RIVER FOREST ZONING BOARD OF APPEALS MEETING AGENDA

SUBJECT: Appeal of the decision of the Zoning Administrator – 558 Lathrop Avenue

OLSHESKY RESIDENCE
NEW SINGLE-FAMILY RESIDENCE

Re: Appeal of the Zoning Administrator's Interpretation of the Zoning Ordinance regarding 558 Lathrop Avenue

BUILDING SECTIONS

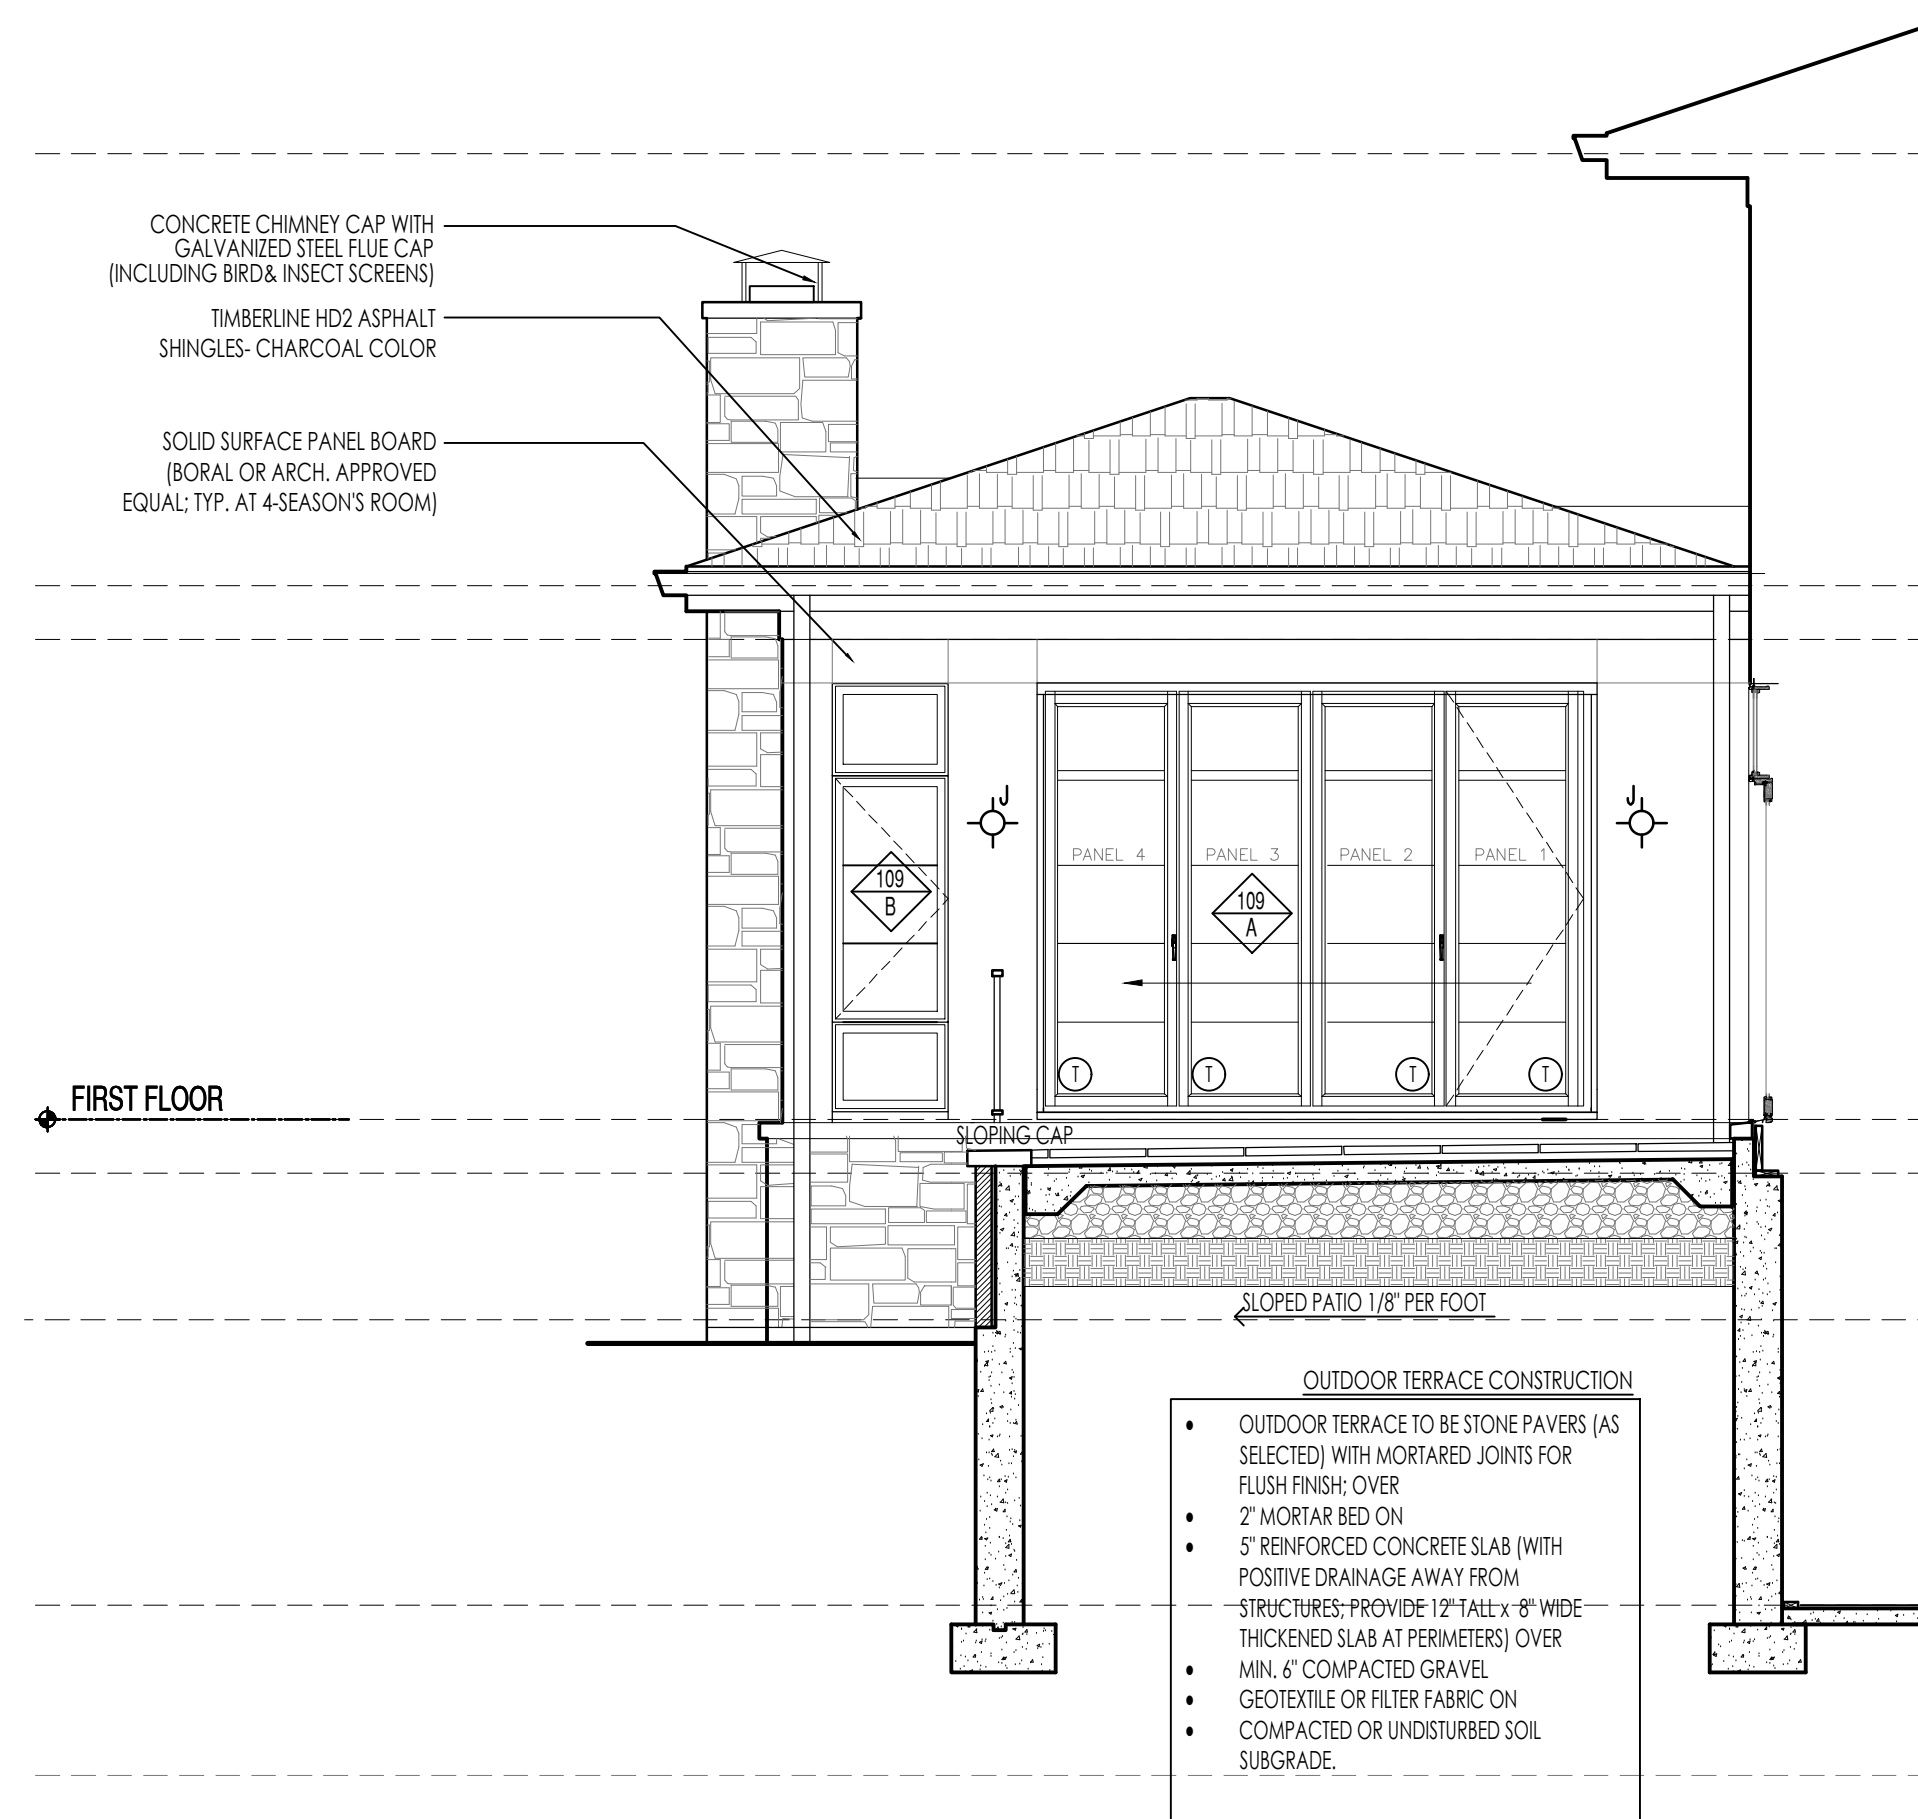
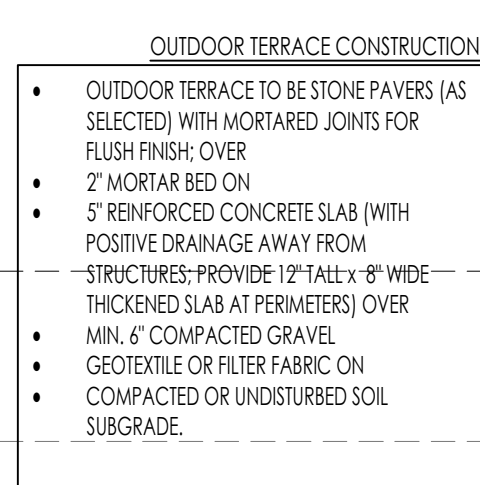
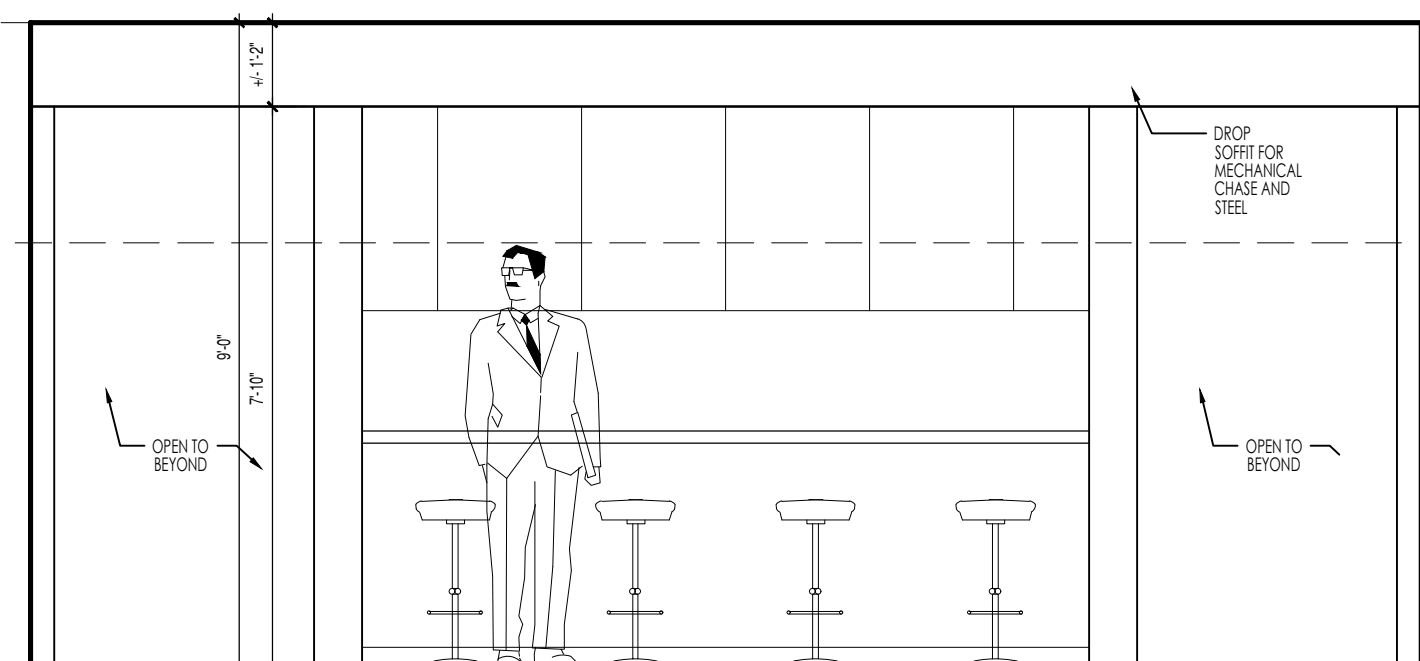
It should also be observed that the Building Elevations and Building Sections correctly relate the maximum Building Height to Grade, the elevation at the public walk.
